Central Ave., ext. Peaks Island
(89-C-1)

June 17, 1969

Permit to construct a 1-story frame addition on rear and to construct 1-story frame addition on the side of the dwelling at the above address is issued herewith subject to the following Building Code requirements:

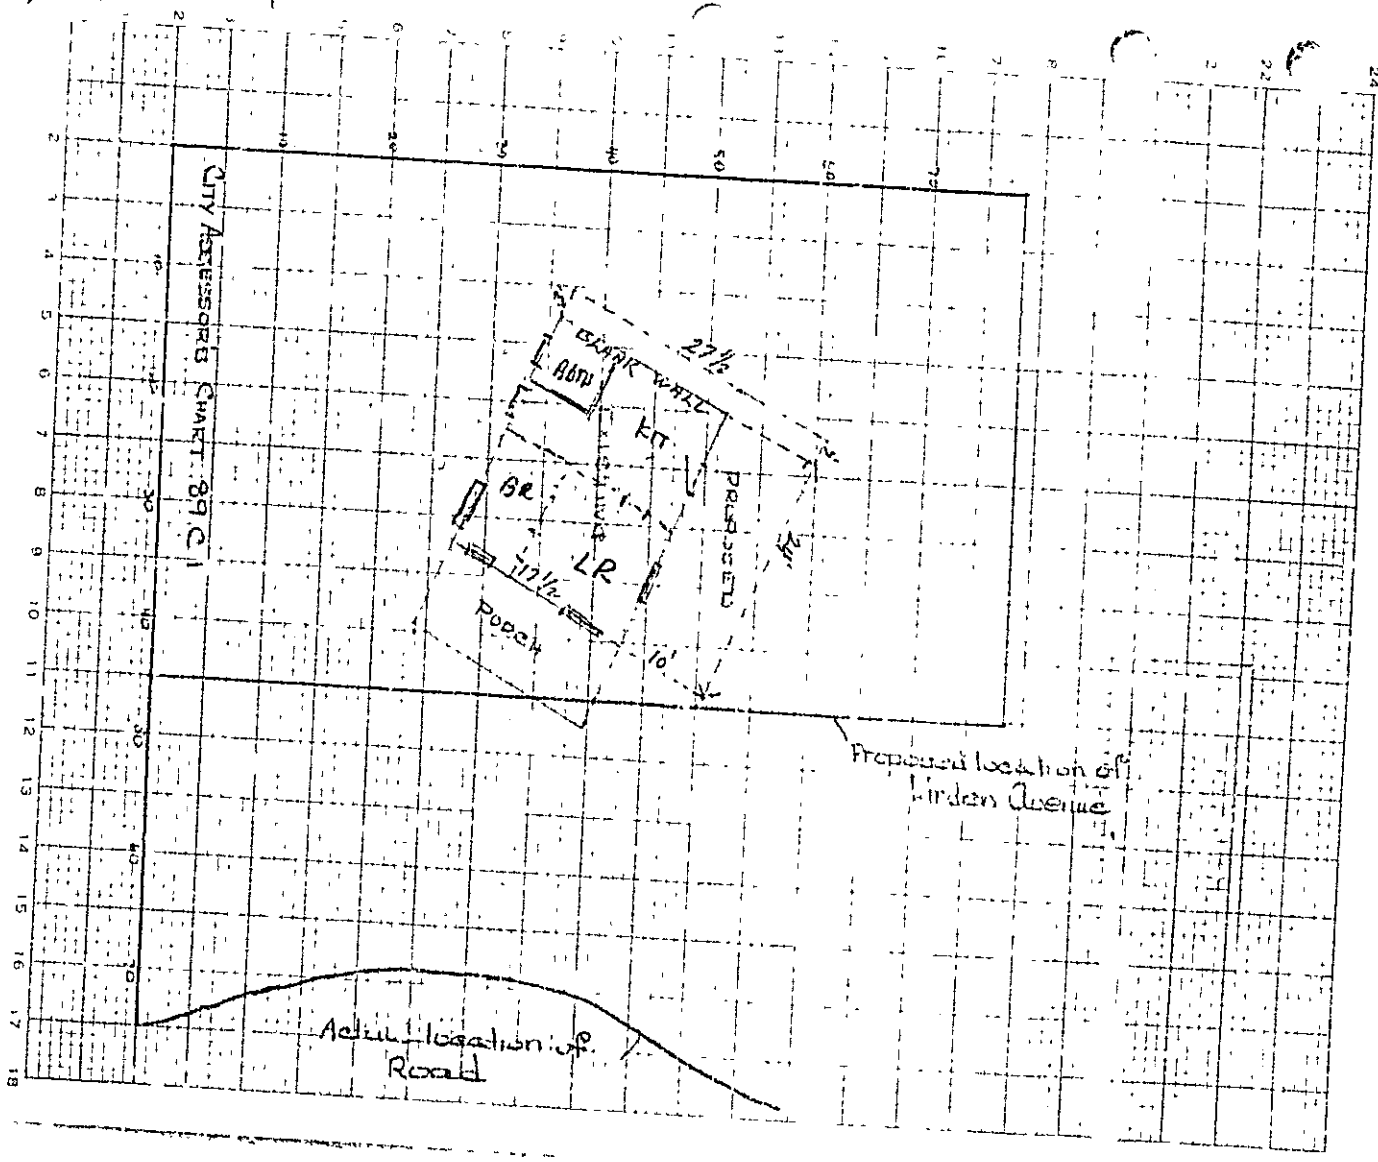
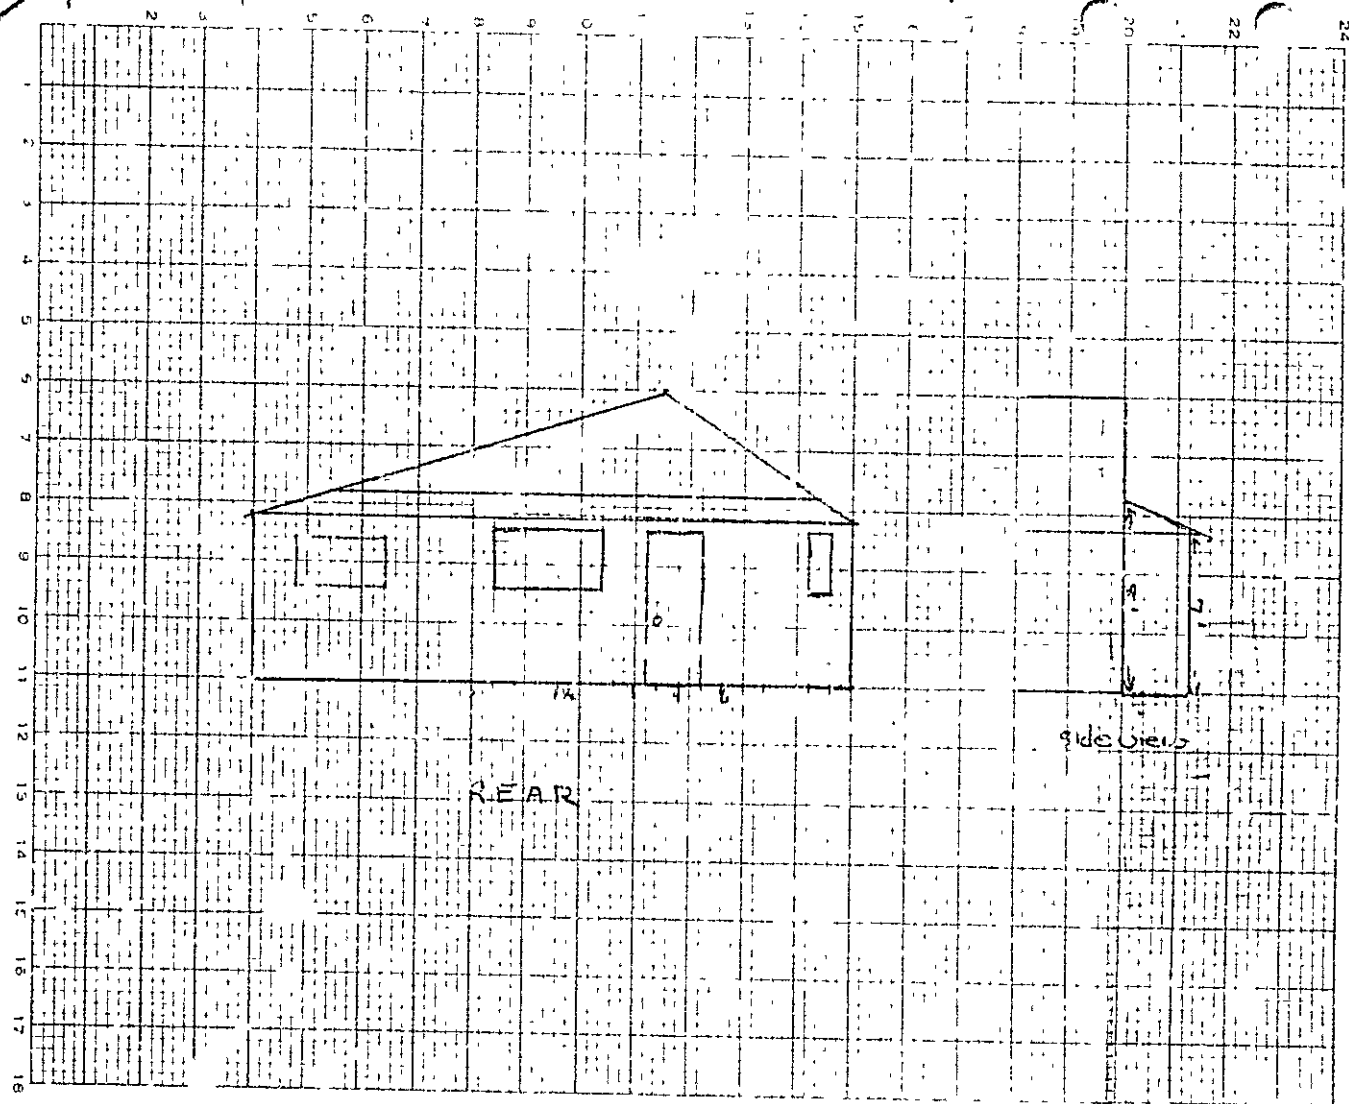
1. Section 1503 of the Building Code requires that the 4x6 sills are required to extend around all three sides of the additions and that they are required to be all one piece in cross section with a 6" dimension upright and the 2x8 floor timbers are to be 16" o. c. notched over a 2x3 nailing strip against the house and the sill.
2. If there are to be any wide openings in the addition please advise this office as to the size of the openings and the size of the timbers to be used as headers so that we may check them against the loads involved.
3. Before concrete is poured into sonstubes this office must be notified for a form inspection. It is also necessary that before any wallboard is applied to the walls that this office will be notified for a closing-in inspection.

4x6
we. ren.
